# CITY PLANNING COMMISSION

- APPLICATION:**
- A. Tentative Map to divide 7 corner lots totaling 1.4+ vacant acres for halfplex development in the Townhouse (R-1A) Zone
  - B. Special Permit for halfplex development in the R-1A Zone

**LOCATION:** Various corner lots, Parkview Estates Unit 4

ADOPTING FINDINGS OF FACT AND  
APPROVING A TENTATIVE MAP FOR  
PROPERTY LOCATED AT VARIOUS CORNER  
LOTS, PARKVIEW ESTATES UNIT NO. 4-  
GLORIA DRIVE AND RUSH RIVER DRIVE  
(P87-077)

APPROVED BY: <u>J.C.A.</u>	CERTIFICATE OF COMPLIANCE EXHIBIT FOR LOT 15 OF PARKVIEW ESTATES UNIT NO. 4, 166 B.M. 14	DATE: 01-28-1987	DRAWN BY: H.K.
		SCALE: 1" = 30'	SHT. 5 OF 7

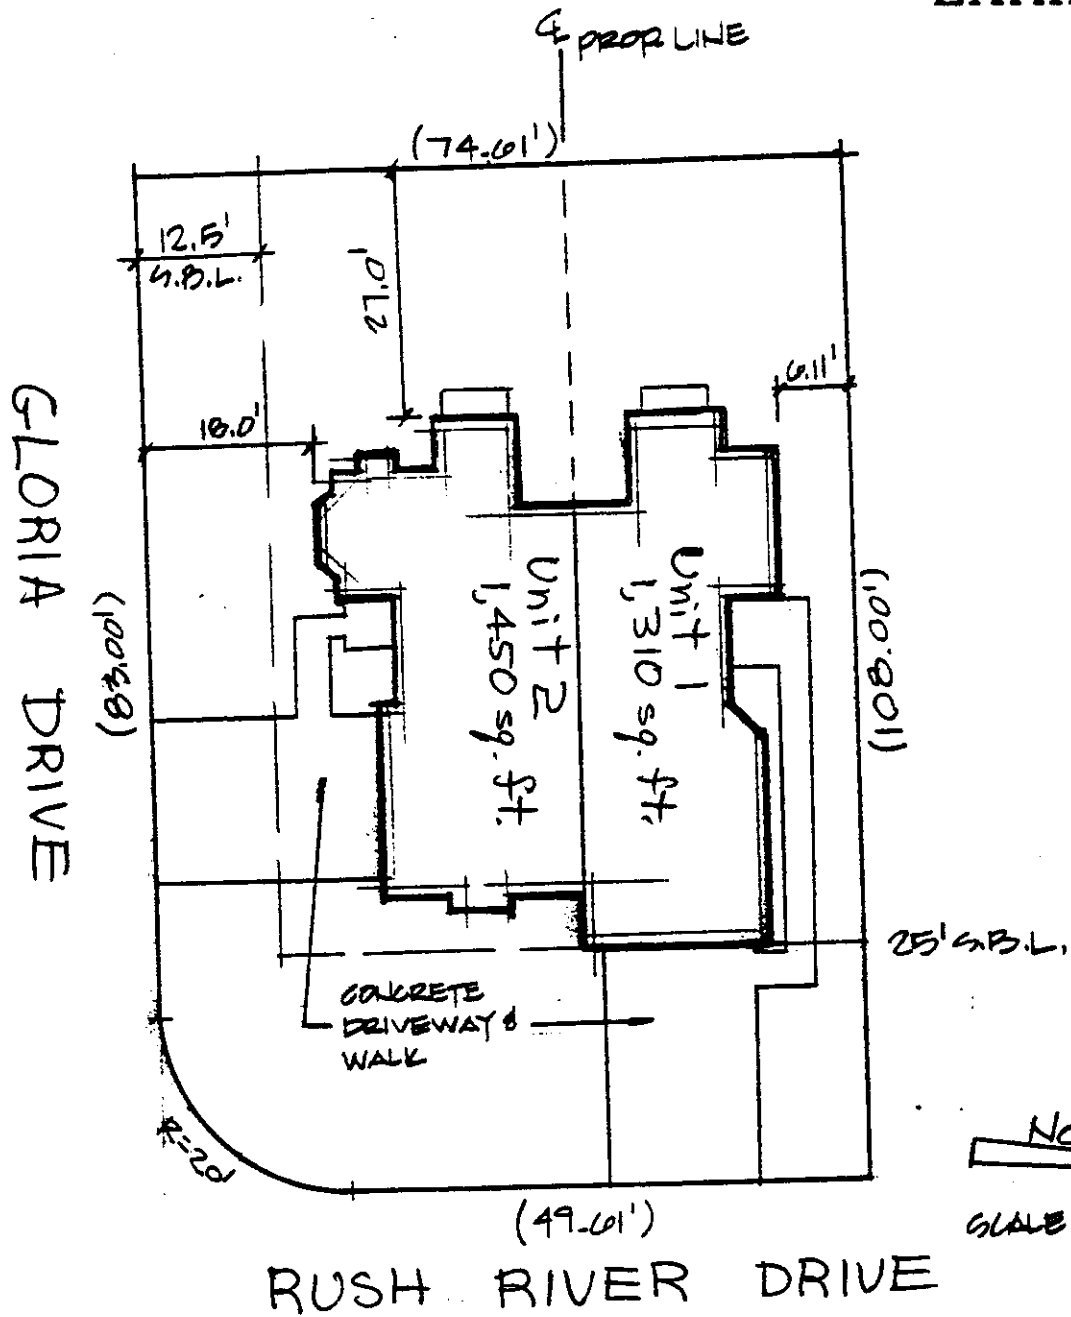
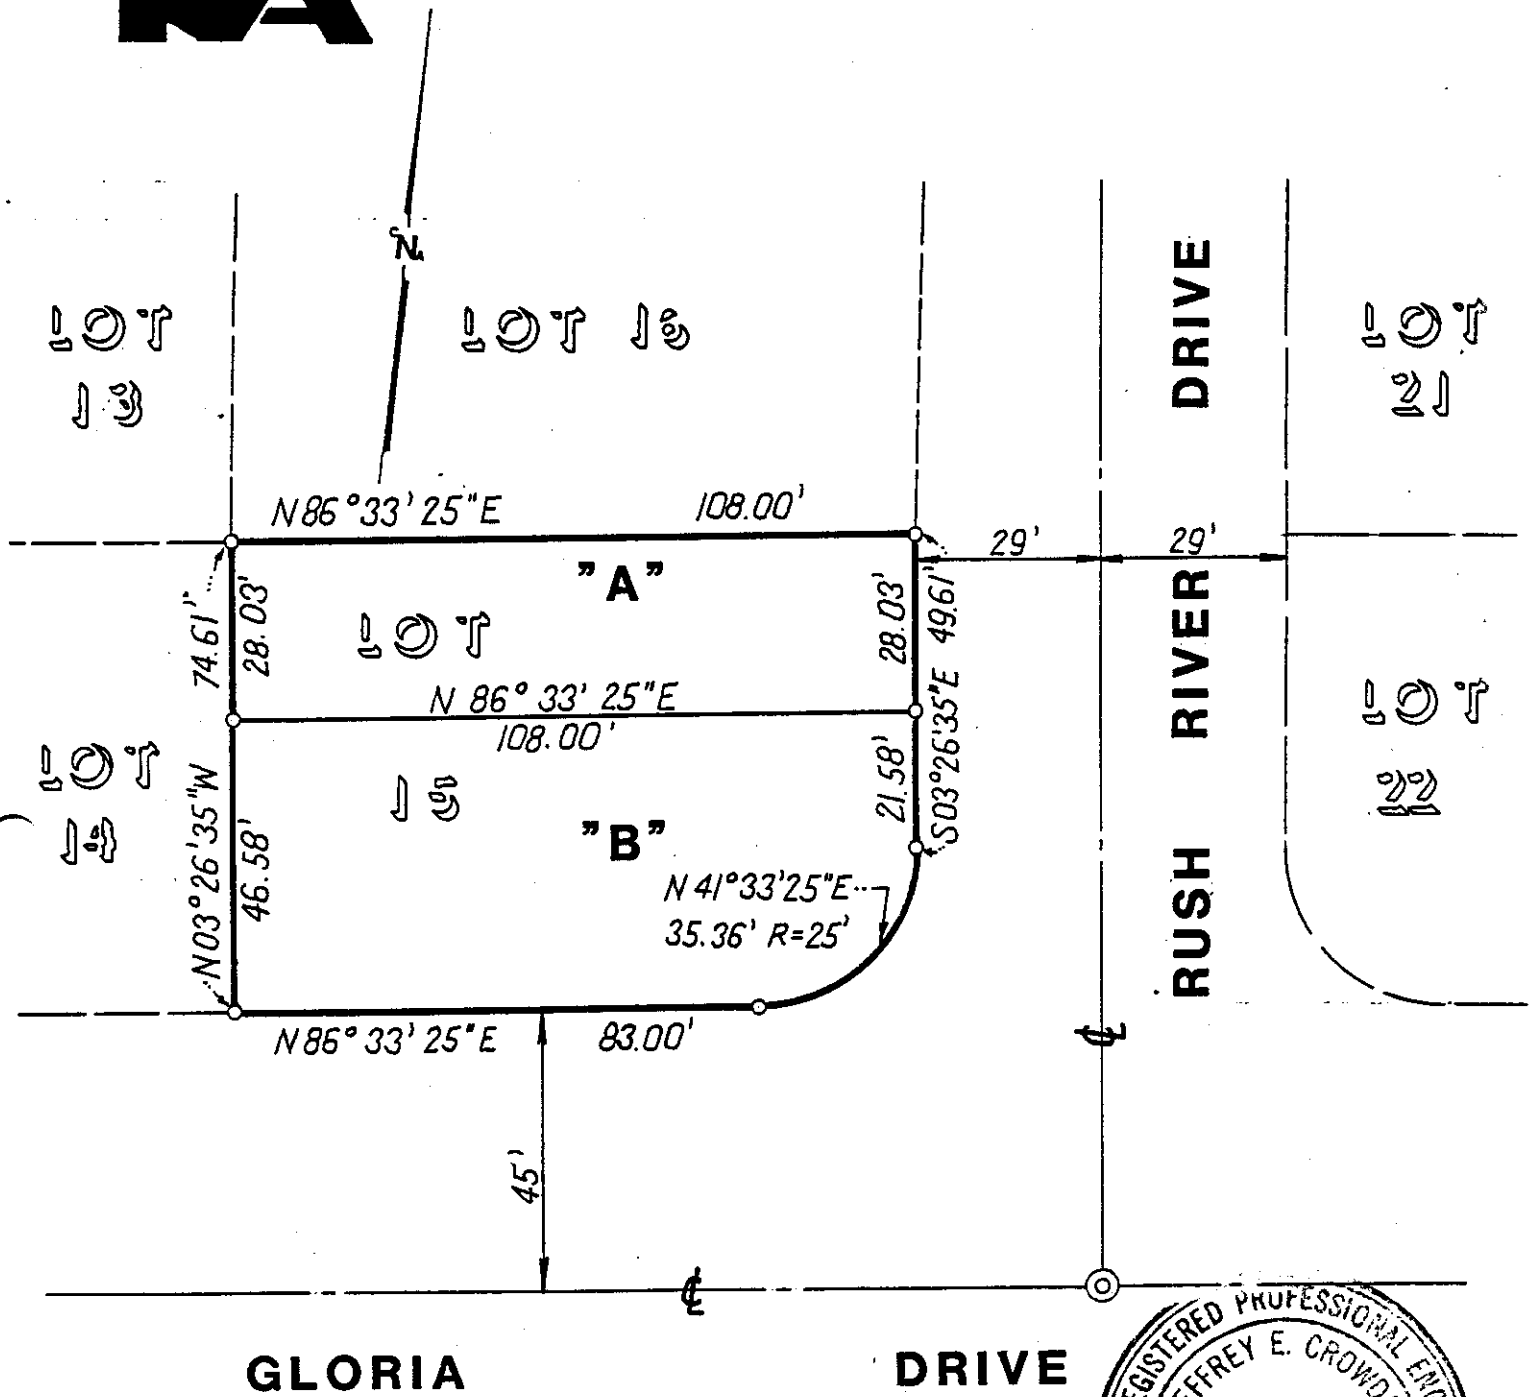
- c. Locate existing sewer and water services;
  - d. Relocate lot line for Lot 15 and possibly Lot 1 to assure that existing water and sewer services are provided to each lot (services shall not be permitted to cross lot lines);

## EXHIBIT I ELEVATIONS

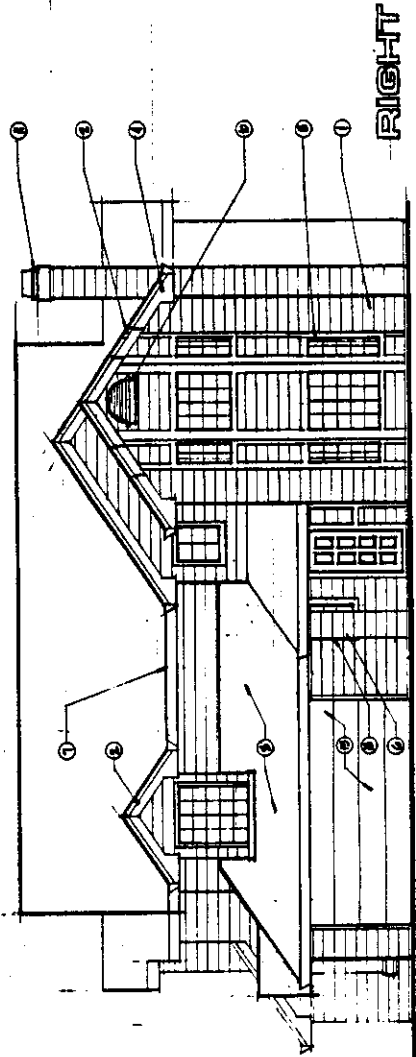
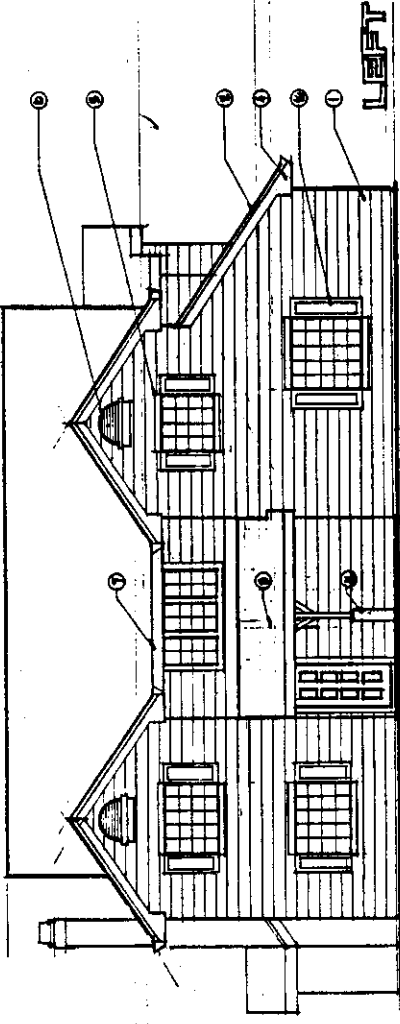
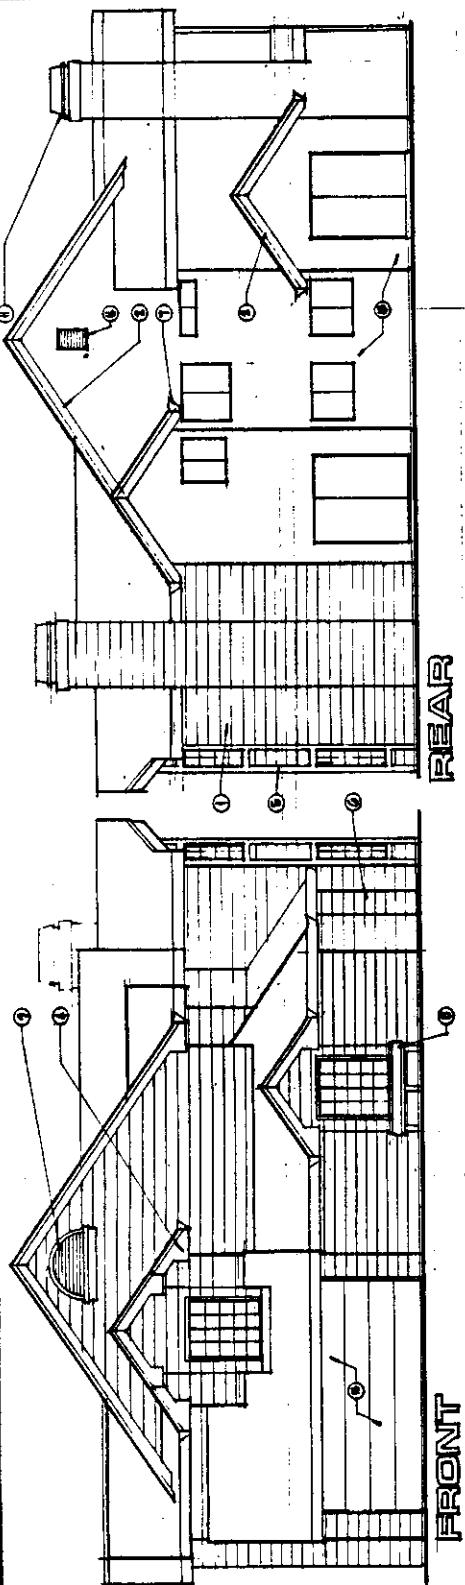
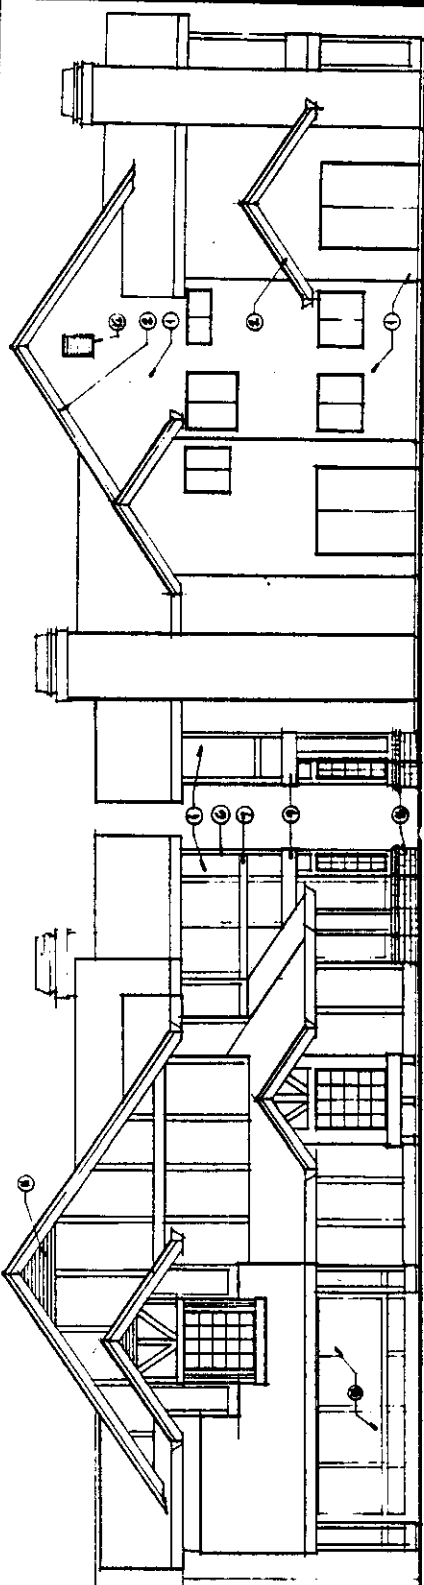
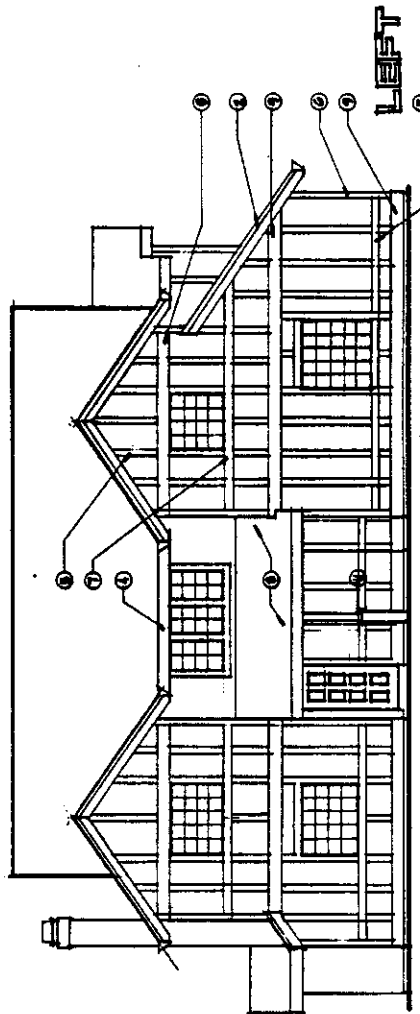
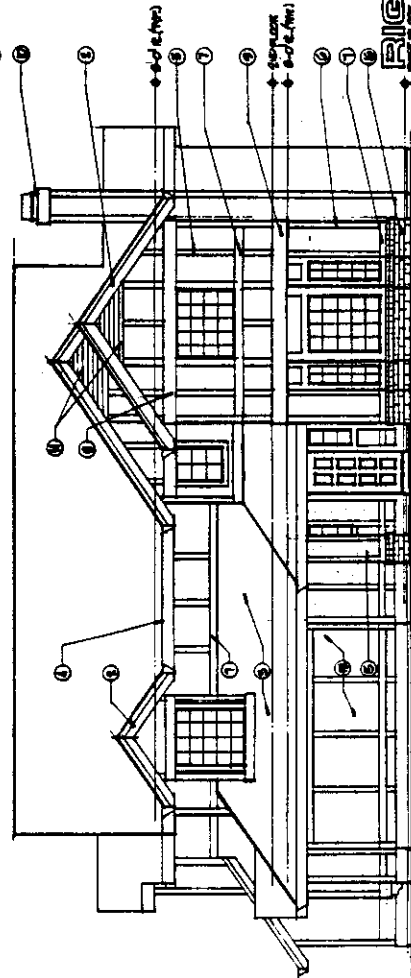
The halfplex units backing up to each other proposed for Lots 7, 8, 14, 15, 22, and 23 have their rear elevations visible from Gloria Drive especially the second story. On the 4 elevations proposed, stucco is the exterior material used on the rear of the units. Staff would support modification to the rear of the units, especially the second story, to be designed similar in accent, trim and architectural amenities as the street frontage. The rear of the seven halfplex units will be visible from Gloria Drive. With modifying the second story rear elevation to continue the architectural style and materials of the front of the units, the proposed halfplex should provide interest and not appear so massive or monotonous as viewed from Gloria Drive.

3. The second story rear elevation shall be modified to be constructed of material similar to the front elevation,. Stucco will not be allowed unless Elevation C and D are used, which are stucco exterior models. Both Elevations C and D have Spanish tile roofing.
